Planning Commission Regular Meeting: October 24, 2023

AGENDA ITEM:	Request by SKB Environmental for approval of the SKB ROSEMOUNT 2nd Addition Final Plat	AGENDA SECTION:	CONSENT AGENDA
PREPARED BY:	Anthony Nemcek , Senior Planner	AGENDA NO.	4.b.
ATTACHMENTS:	Site Location, Final Plat, Preliminary Plat, SKB Expansion Plan, Parks And Recreation Director's Memorandum Dated October 18, 2023, Engineer's Memo dated May 10, 2022	APPROVED BY:	AK, JH
RECOMMENDED ACTION: Motion to recommend the City Council approve the Final Plat for SKB 2 nd Addition subject to the following conditions: 1. Approval of a subdivision agreement. 2. Payment of cash-in-lieu of land dedication in the amount of \$280,000. 3. The park dedication requirement for Outlot A shall be met with the development of that parcel. 4. The plat shall be updated to include a thirty foot wide trail easement along the southern boundary of the plat area. 5. Site development shall conform to all requirements of the City Engineer included in the attached memorandum dated May 10, 2022. 6. Submittal of a landscaping surety will be a condition of approval of any future site plan review.

Re: SKB Rosemount 2nd Addition
Preliminary Plat R

PRELIMINARY PLAT - SKB ROSEMOUNT 2ND ADDITION

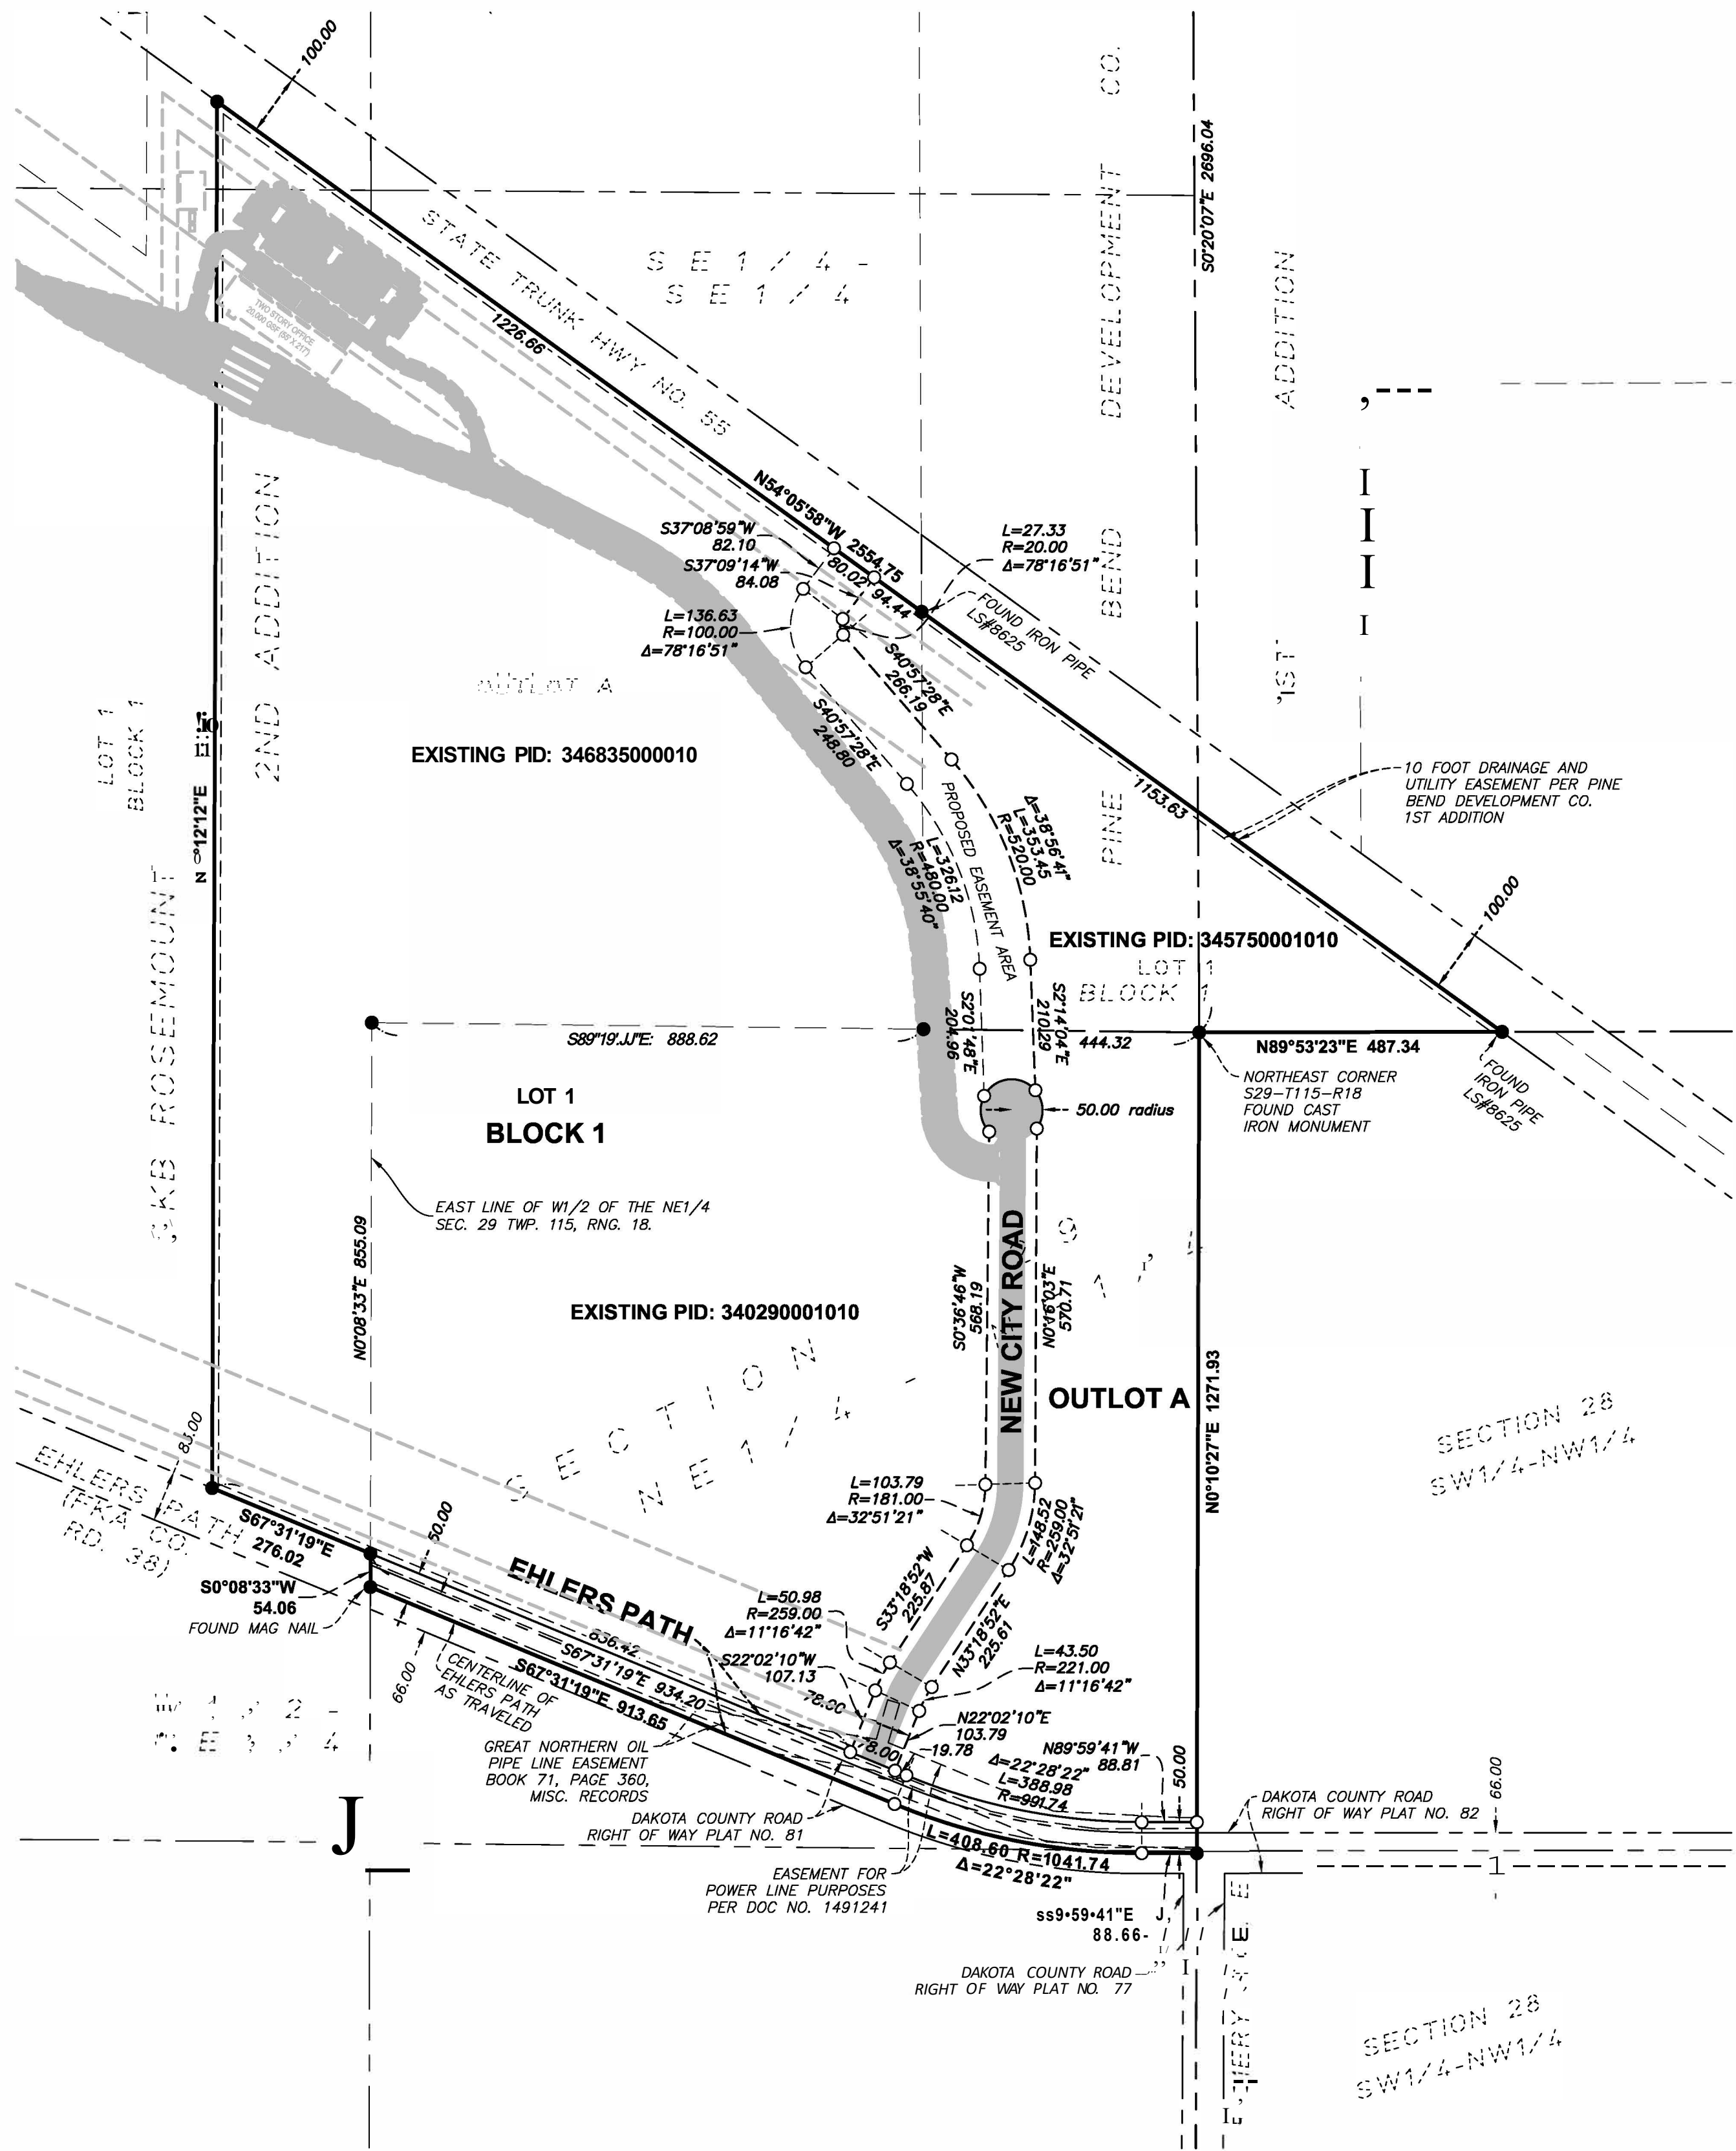
destroy the existing pavement as the current pavement is not adequate to accommodate heavy truck traffic. The proposed city street is shown to have right of way dedication from Ehlers Path to TH 55 but only the southerly portion is identified to be constructed at this time. The northerly right of way alignment has a sharp curve immediately south of its intersection with TH 55. The minimum street centerline radius must be increased to 300 feet.

- Watermain Trunk Charge: \$6,500/acre
 - Storm Sewer Trunk Charge: \$6,865/ net developable acre
2. The proposed future street extending from TH 55 must have a minimum 300-foot centerline radius. Revise the street centerline or straighten the road.

3. The proposed access and egress from the site will utilize Ehlers Path between the proposed street and CSAH 42. Ehlers Path does not have pavement structure adequate to support heavy truck traffic.

5. Verify that the proposed driveway from the future City street will accommodate truck turning radii.
6. The pavement extending around the buildings must be more than 20 feet from the building for fire equipment access and operations.

7. The right-of-way width for the city street must be shown on the site plan. The minimum width for a rural section street is 100-feet.

8. FES 108 to FES 109 does not have cover over the pipe.
9. Fes 106 to FES 105 does not have cover over the pipe.
10. There are several drainage arrows that conflict with each other.
11. Provide a plan and profile view of the city street between TH 55 and Ehlers Path.

12. The ponding area in the southeast corner of the plat will flood across Ehlers Path before water elevations reach the culvert elevation of FES 103.
13. Outlet FES must have riprap erosion protection extended to the bottom of the ponding basin.

14. The watermain extension along TH 55 and within the future City street is 16 inch.
15. Hydrant locations and spacing need to be modified so spacing does not exceed 400 feet.
